RFQ NUMBER
 PTR12011

**HERE AND THERE TRANSIT
BUS STORAGE & ADMINISTRATION FACILITY
PHILIPPI, WEST VIRGINIA**

ADDENDUM NO. 2

SHEET C101

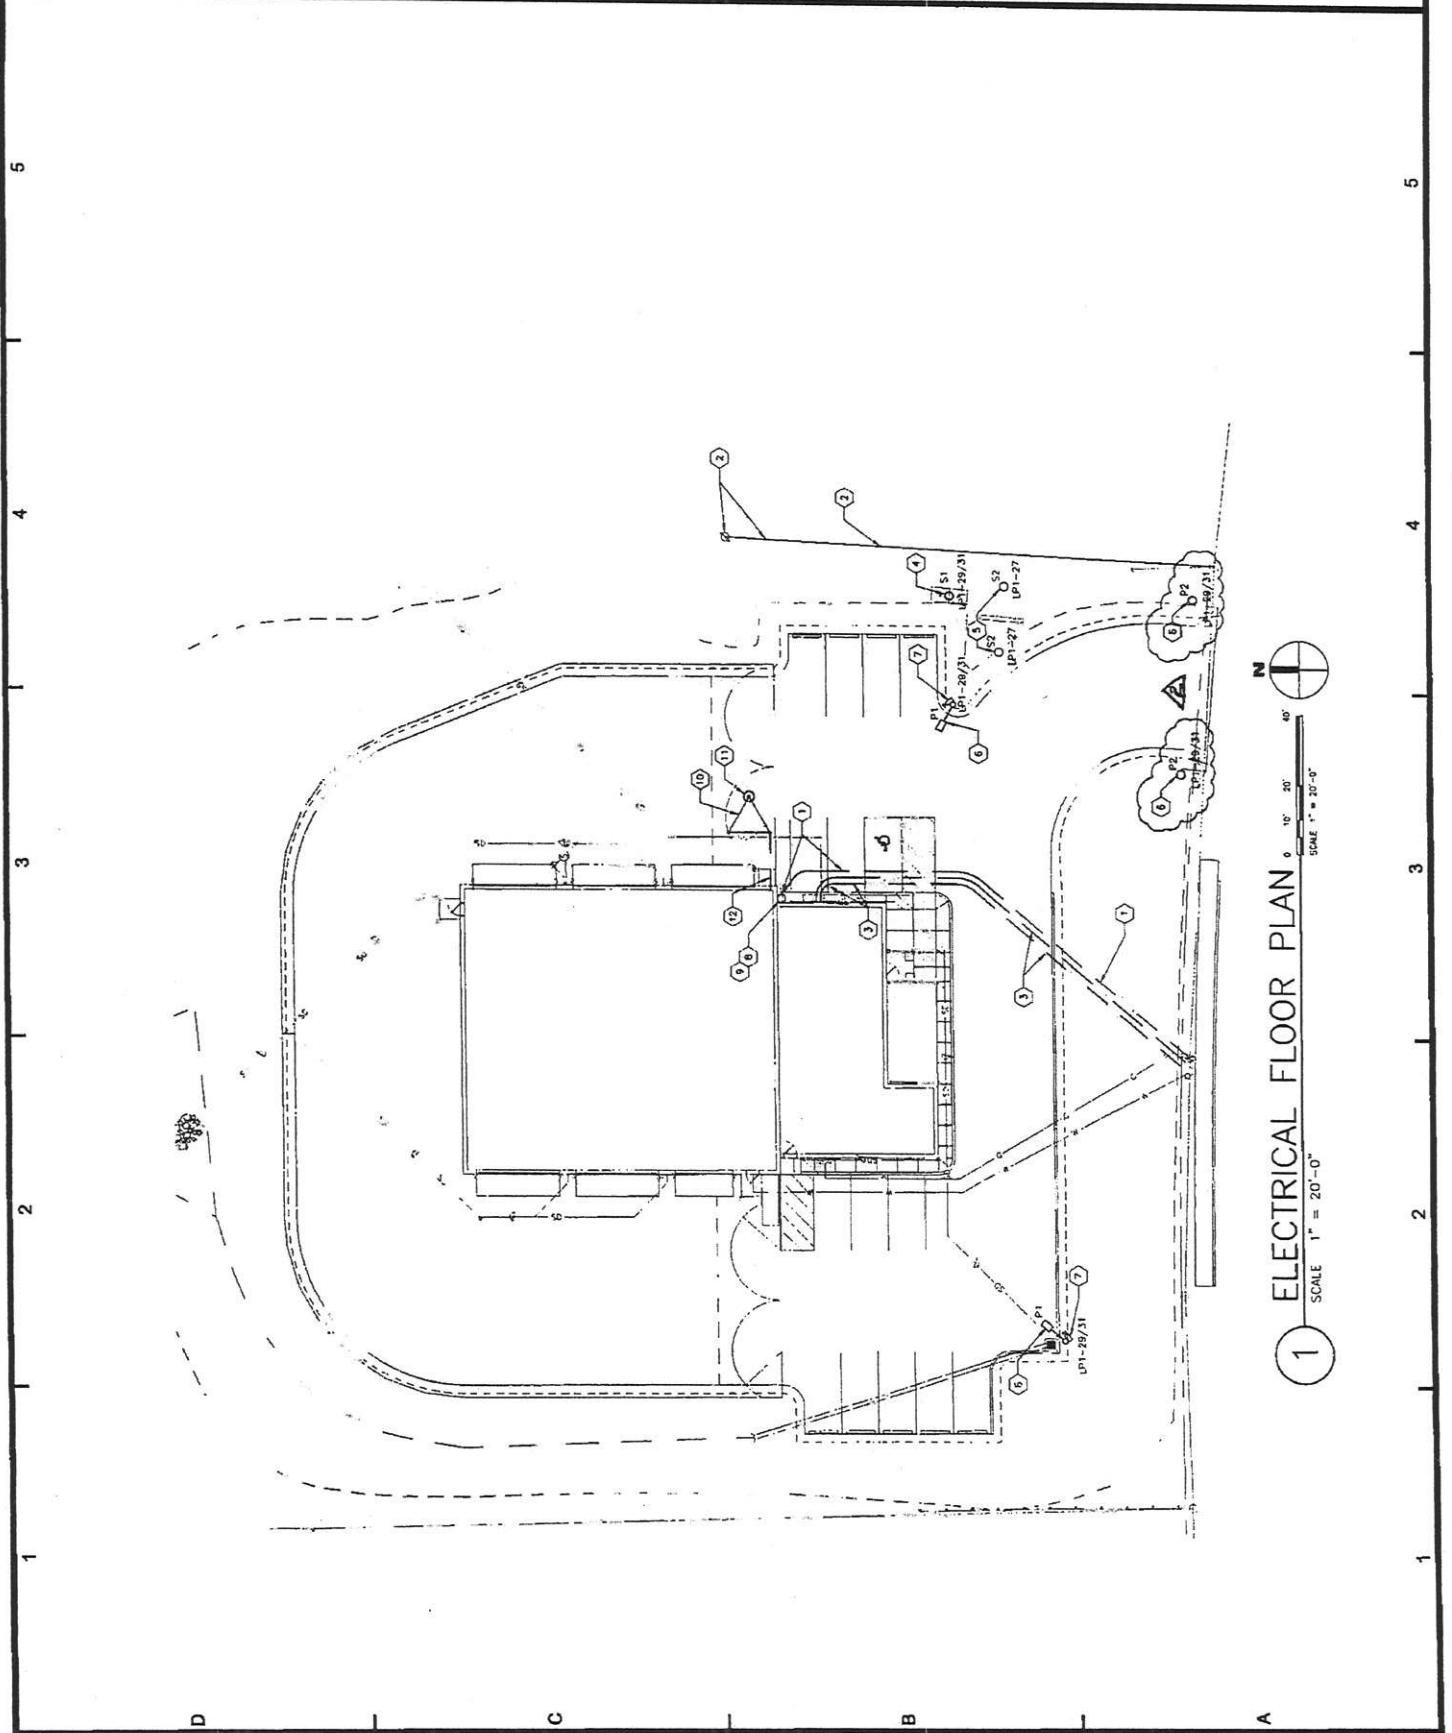
SUBSOIL CLARIFICATIONS:

1. The area encompassing all boring locations has been filled with un-engineered fill materials in the past. These materials will have some miscellaneous debris (concrete, brick, metal, wood, etc.) mixed into this material.
2. Concrete, brick and other acceptable mineral based material debris can remain in structured fills as long size requirements are met for engineered fill requirements.

BORING B-8

3. Sanitary trench excavation passes adjacent to this boring; also rock protrudes from the ground near property corner just south of manhole.
4. Refusal depths at 4' noted in Boring B-8 shall be interpreted as rock excavation when excavating the sanitary line in this area.
